Cutblock discussions and verification of landforms were originally conducted during a field trip on October 8, 2015 by RDI with BCTS, and field resource people in attendance. RDI produced a VIA report based on those discussions. A revised proposal was received from BCTS in 2018. This visual assessment considers each and all of the proposed cutblocks. RDI was not provided the opportunity to assess Viewpoints 1 through 9 on-site and cannot verify the accuracy of the simulations from those viewpoints. On-site validation is recommended to determine roadside screening from all viewpoints.

Ken B. Fairhurst, PhD, RPF
RDI Resource Design Inc
July 27, 2018

Summary of Cutblock / Landform Findings

Albreda 2018 - VP 12 - 1733 - Percent Alteration

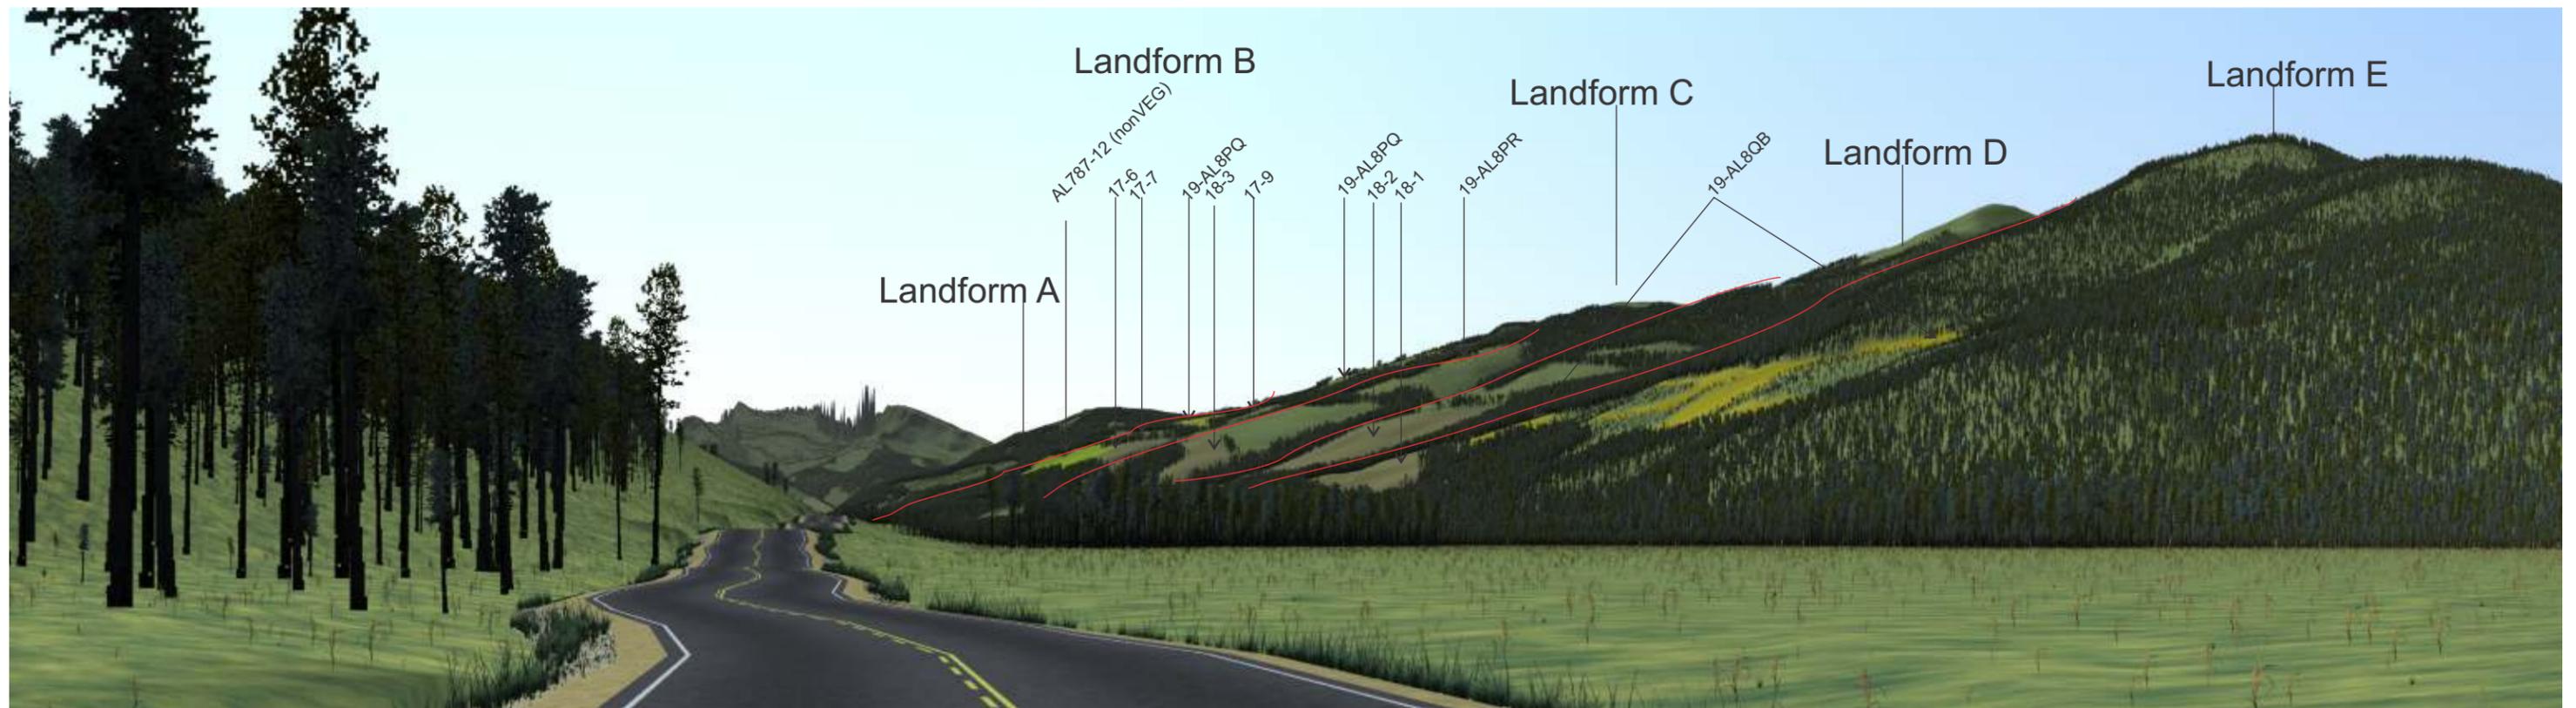
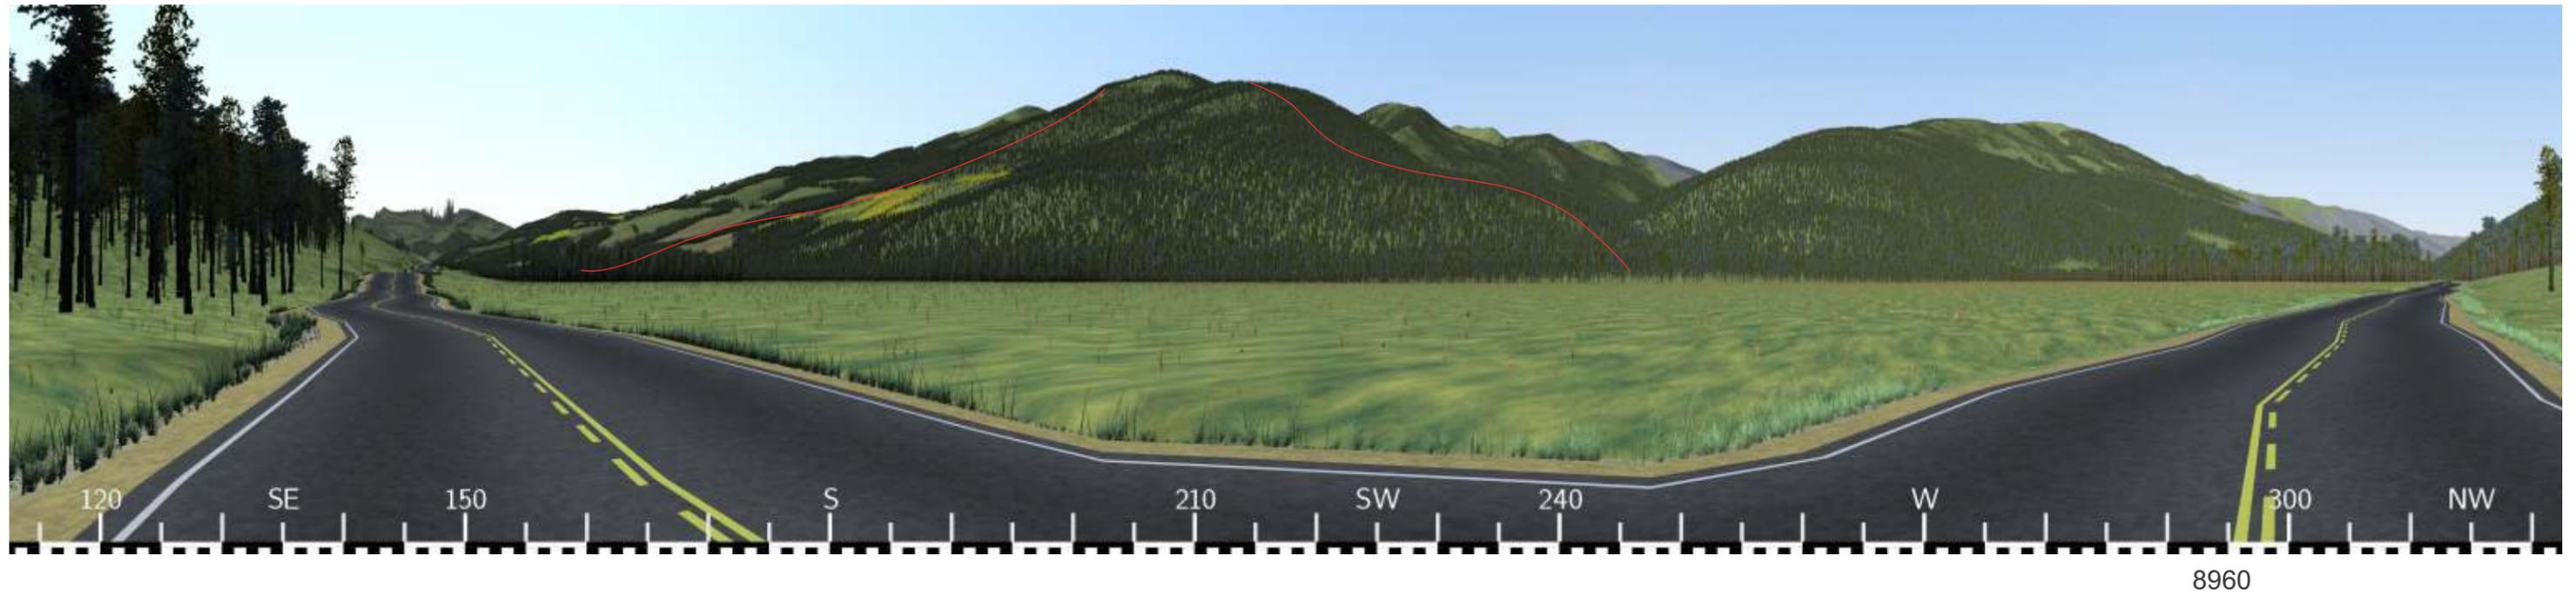
*Landform D is somewhat narrow in this oblique view towards it. Cutblock 18-2 is 8.7% of the landform on its own. See Viewpoint 11 for a more direct view of Landform D (9.0% Alteration - indicating VQO exceeded from both viewpoints). Combining Landforms D and E together for percent alteration calculation brings overall D+E percent alteration within the limits of Partial Retention VQC. However, individual numbers suggest both reduction in scale and refinement of geometric shape of 18-2 is required.
